Product Change Notification: DSNO-18SQTN760

CCB 7580 Final Notice: Qualification of ATP7 as an additional assembly site for selected MIC2875 and MIC2876 device families available in 8L UDFN (2x2x0.6mm) package.

Pre and Post Change Summary

Lead-Frame Comparison

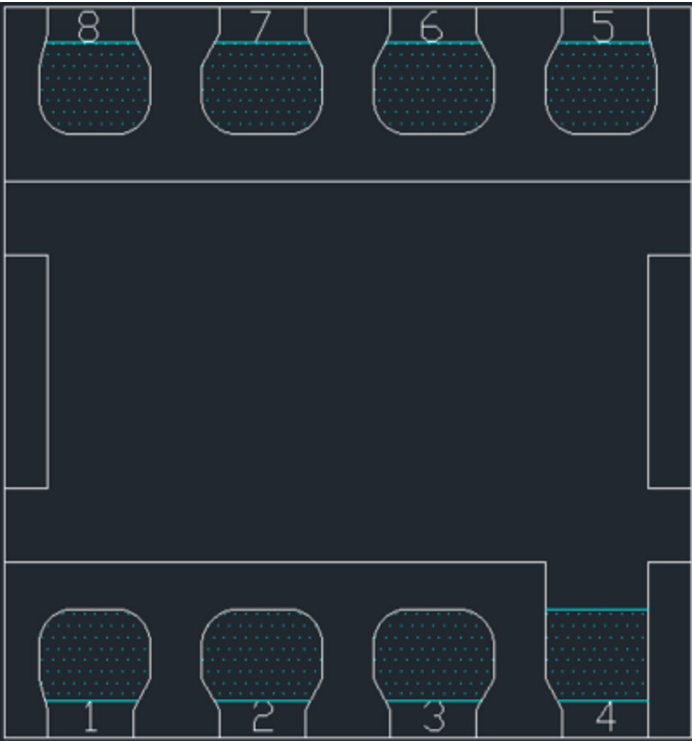
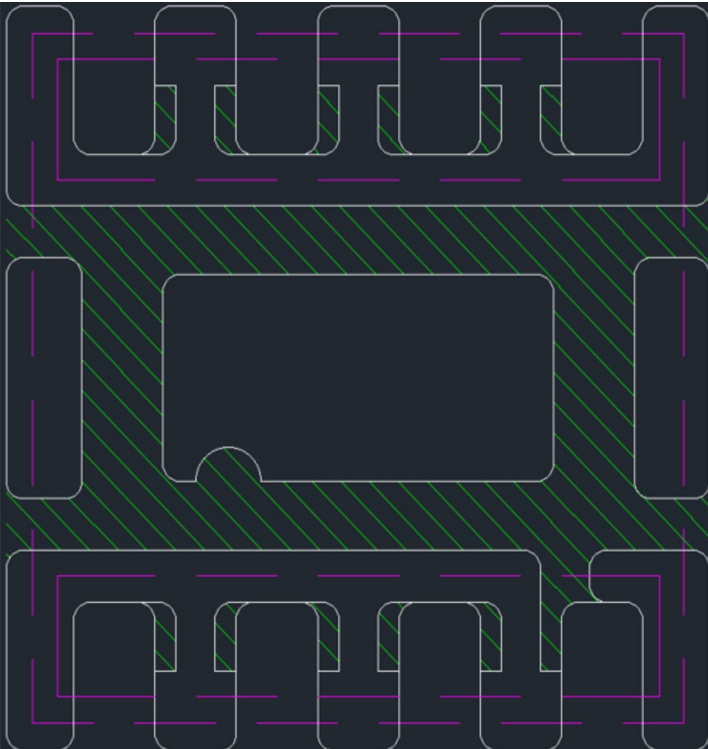
Note: Not-to-scale													
<table><tr><td>Lead-Frame Material</td><td>C194</td></tr><tr><td>DAP Surface Prep</td><td>Spot Ag</td></tr><tr><td>Lead-Frame Paddle Size</td><td>69x41mils</td></tr></table>	Lead-Frame Material	C194	DAP Surface Prep	Spot Ag	Lead-Frame Paddle Size	69x41mils	<table><tr><td>Lead-Frame Material</td><td>C7025</td></tr><tr><td>DAP Surface Prep</td><td>Ring Ag</td></tr><tr><td>Lead-Frame Paddle Size</td><td>67x39mils</td></tr></table>	Lead-Frame Material	C7025	DAP Surface Prep	Ring Ag	Lead-Frame Paddle Size	67x39mils
Lead-Frame Material	C194												
DAP Surface Prep	Spot Ag												
Lead-Frame Paddle Size	69x41mils												
Lead-Frame Material	C7025												
DAP Surface Prep	Ring Ag												
Lead-Frame Paddle Size	67x39mils
